# **OXFORDSHIRE COUNTY COUNCIL'S RESPONSE TO CONSULTATION ON THE FOLLOWING DEVELOPMENT PROPOSAL**

**Application no:** 21/03268/OUT

**Proposal:** Outline planning permission (all matters reserved except for access) for the erection of buildings comprising logistics (Use Class B8) and ancillary Office (Use Class E(g)(i)) floorspace; construction of new site access from the B4100; creation of internal roads and access routes; hard and soft landscaping including noise attenuation measures; and other associated infrastructure

**Location:** NW Of Baynards House, Ardley

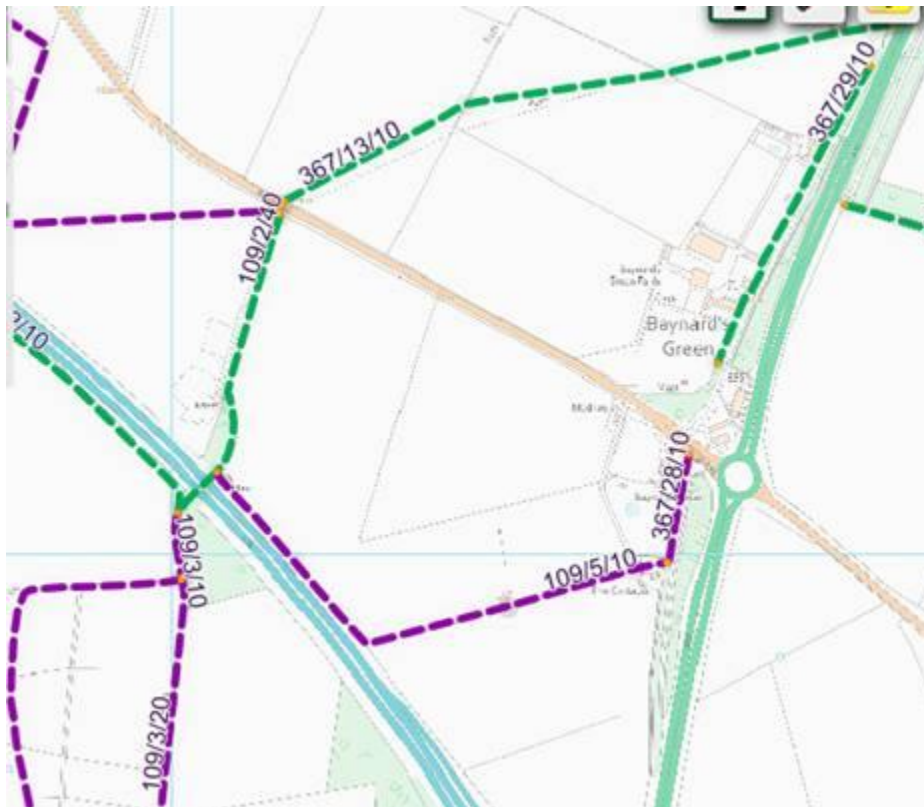
Footpath 109/5/10 is proposed to be diverted as it passes through the site. OCC would like to see this dedicated as a bridleway at the same time as any diversion, which would allow for cycling, and complete a missing link between Stoke Lyne Bridleway 367/29 and Ardley Bridleway 109/2. This could be a 3m wide tarmac path with a verge on either side. See map and annotations below. This comment is made without prejudice to the desirability/outcome of any application to divert PRow. The existing/altered footpath connection to opposite the services should be retained.

The preferred alignment would be as shown below, and make use of the 3m wide cycle connection to the site, although as stated above, it would be better within the site rather than alongside the B4100. An improved crossing point leading across the B4100 into the service area site, would provide an onward connection to brideway 367/29. As the area of highway land on the western side of the service area access is quite wide, it should be separated from the access road by a verge until it can connect with the access road at a safe point.

It is suggested that a bridleway/cyclepath margin is provided for within the red line of the site rather than trying to upgrade footpath 367/28 which has a potentially hazardous road crossing.
